PLANNING TECHNICAL REVIEW COMMITTEE –AGENDA

Re: Dover Heights (P-19-15)
Redevelopment of 1 First Street, Dover, NH
Technical Review Committee Minutes, Site Plan Review, March 7, 2019
KNA Project No. 17-1219-1

RESIDENTIAL SITE PLAN

DOVER HEIGHTS

FIFTH FLOOR PLAN
1/16" = 1'-0"

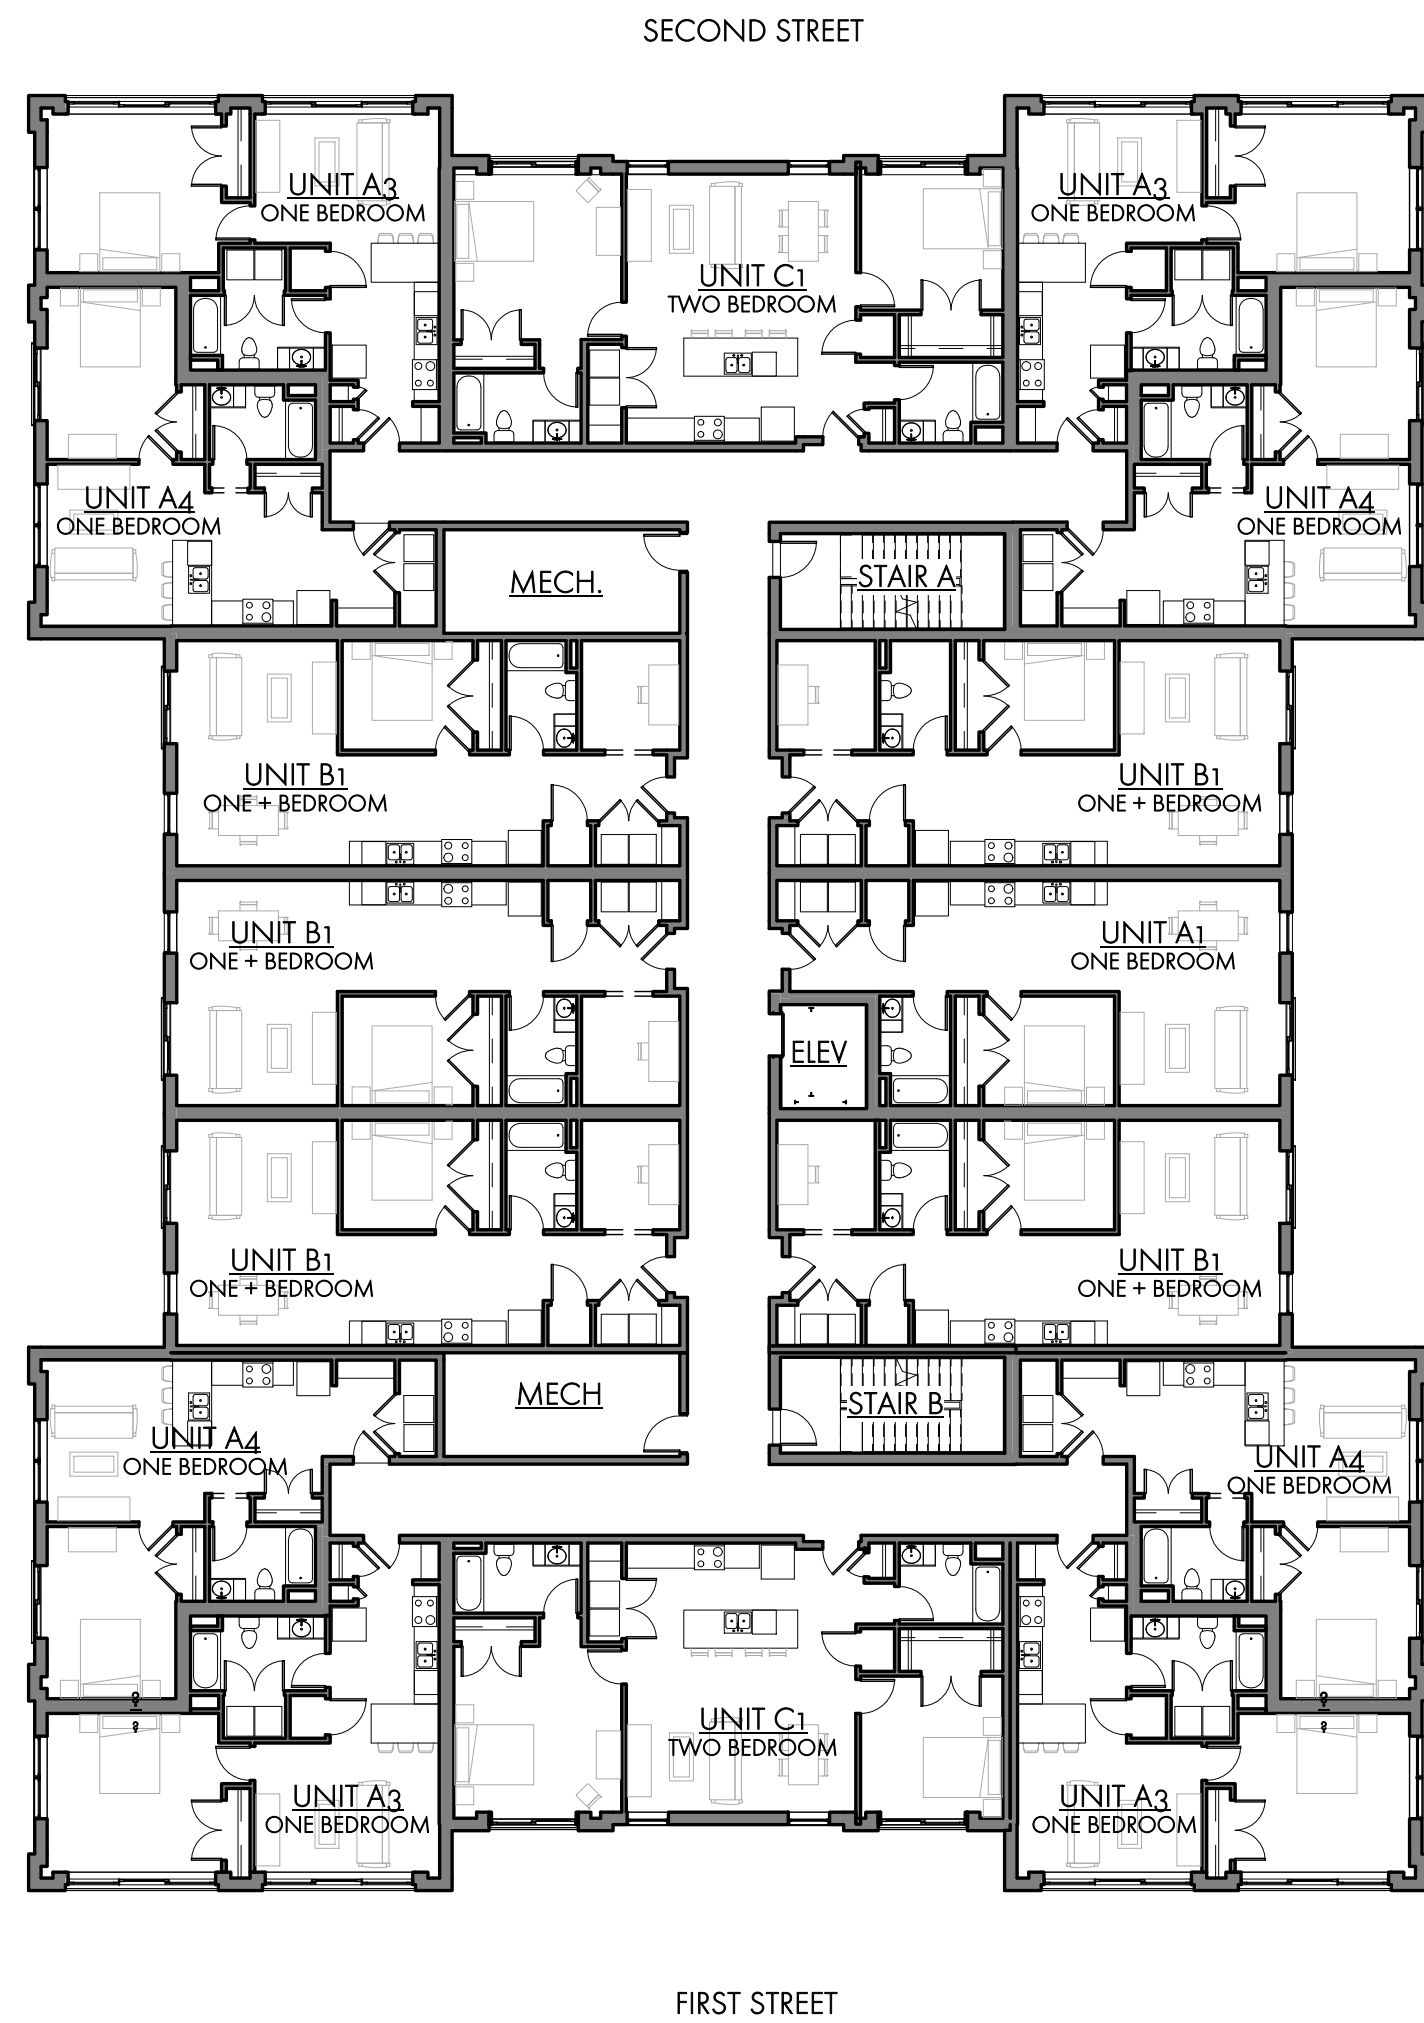
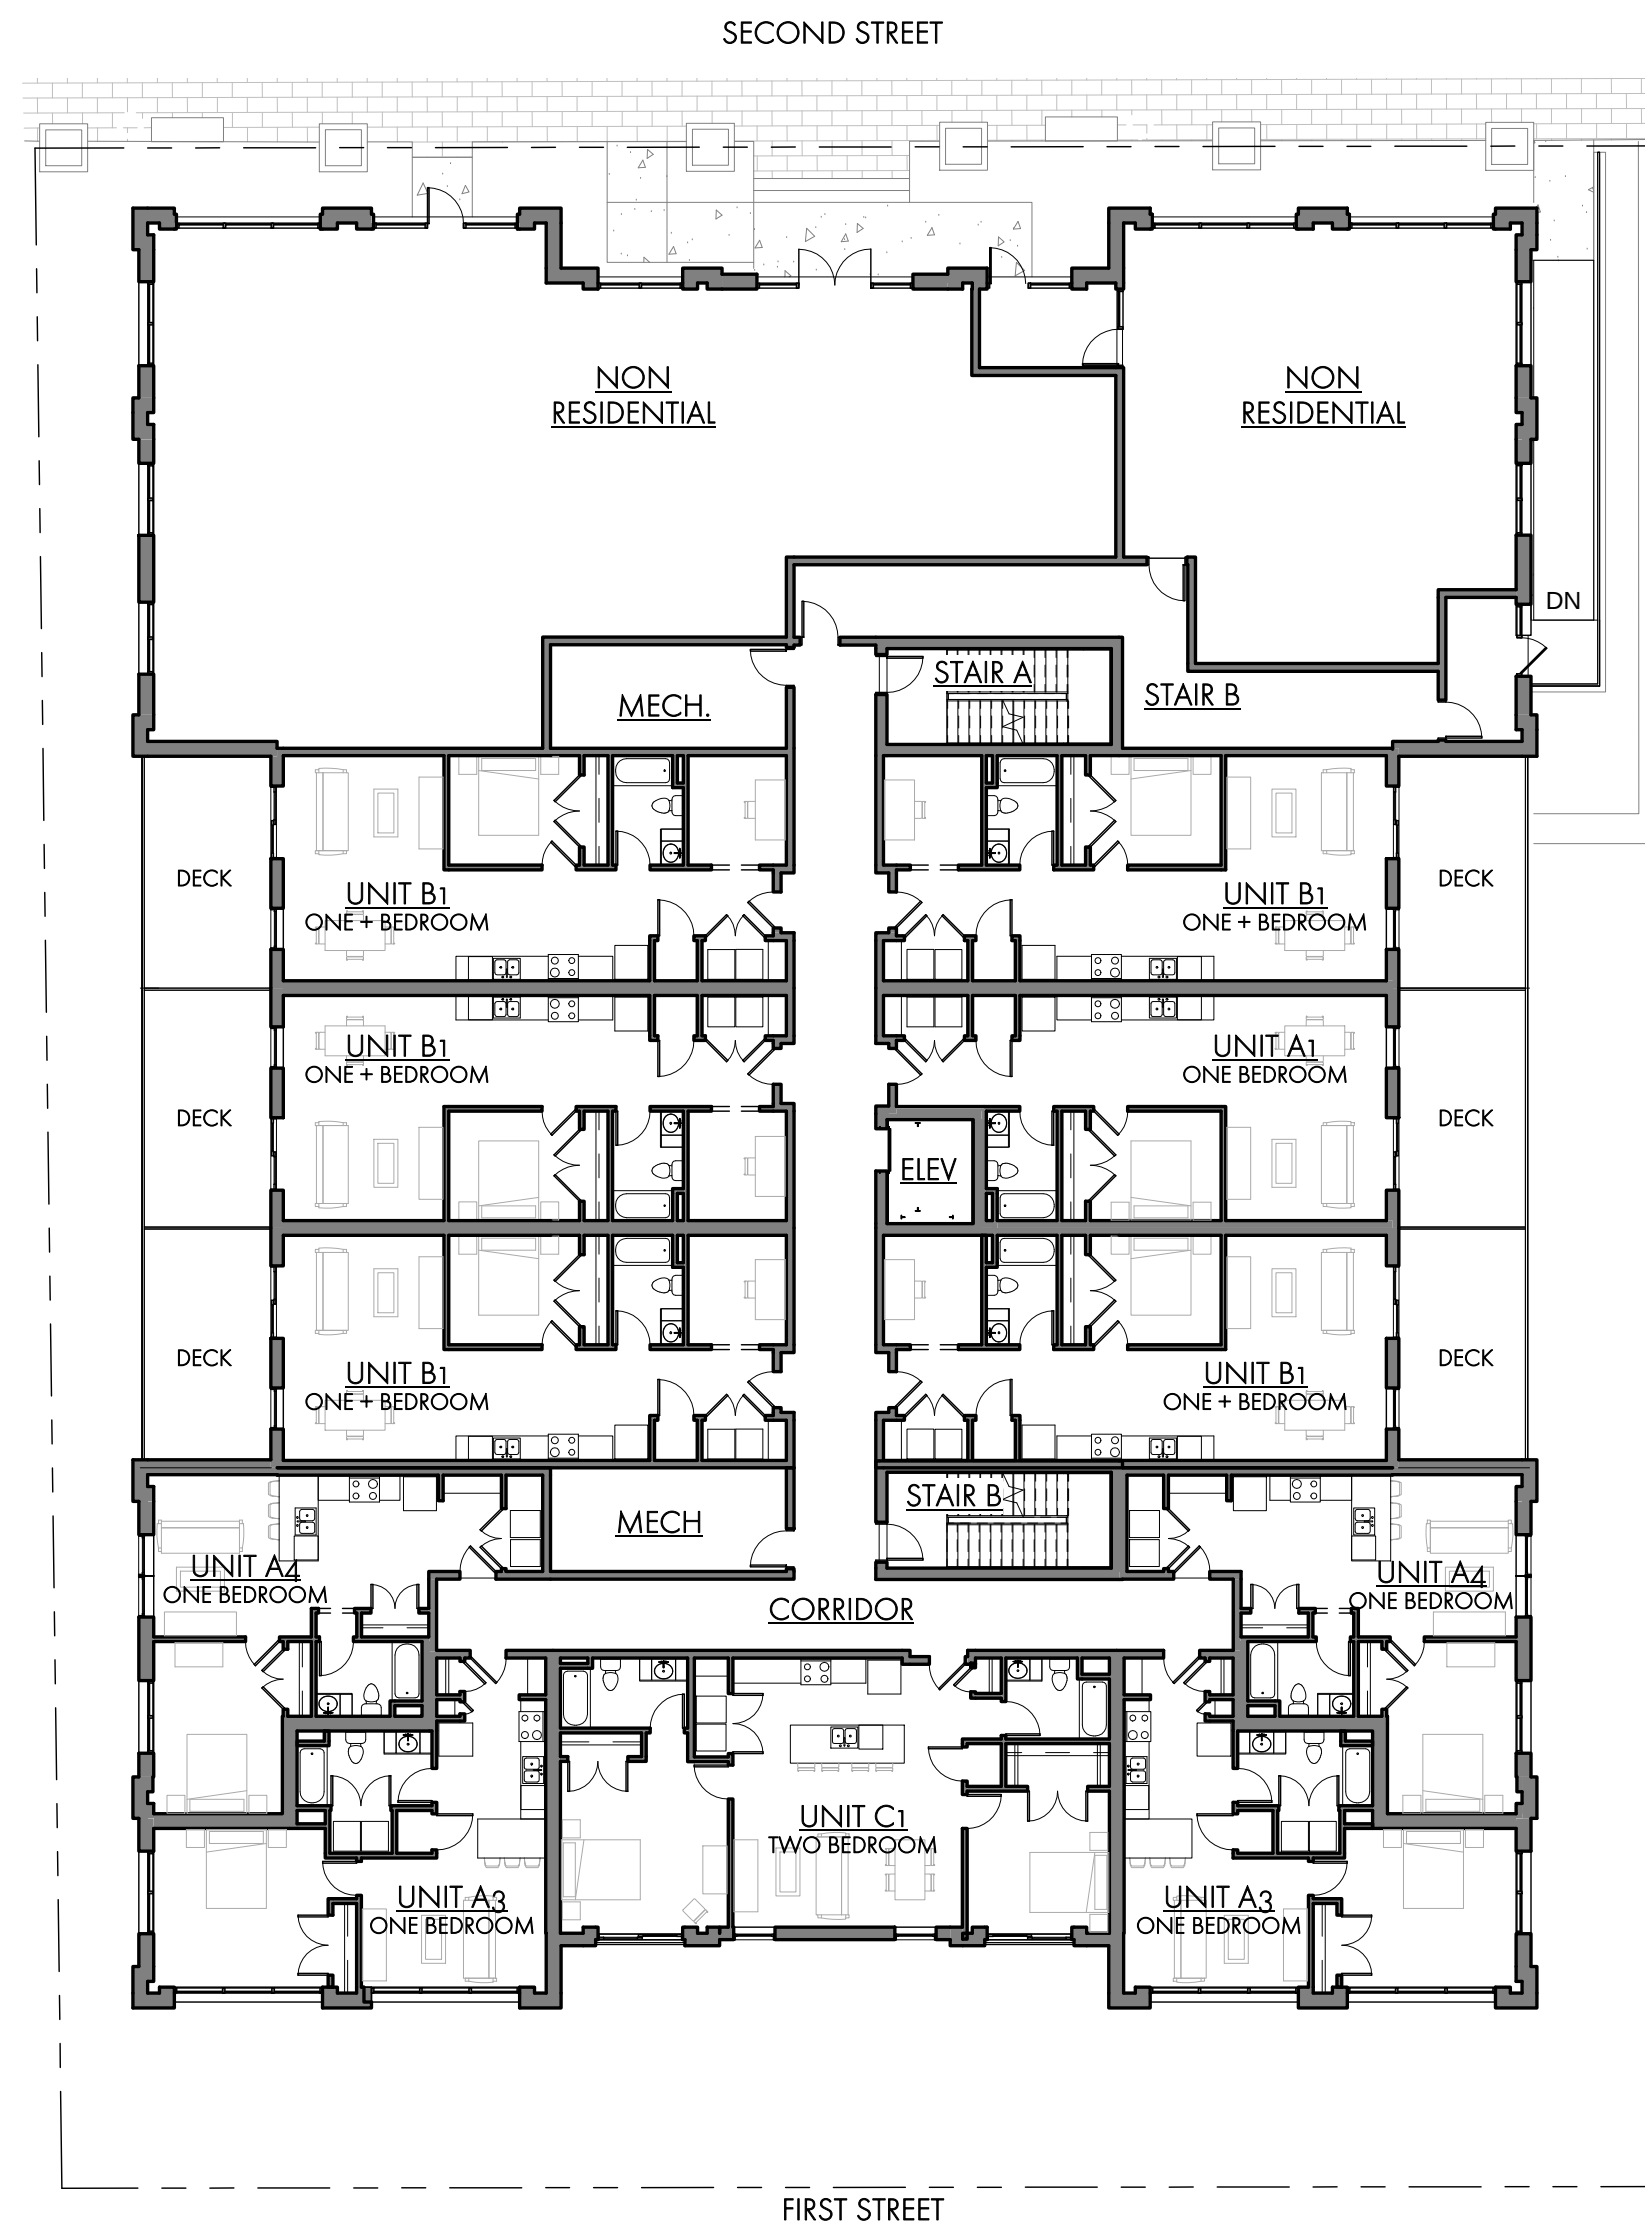
- The Landscape Plan (sheet 8) legend was updated.*
- i. Correct floor numbers on floor plan.
- The floor plans have been revised.*
- j. Indicate materials on building elevations.
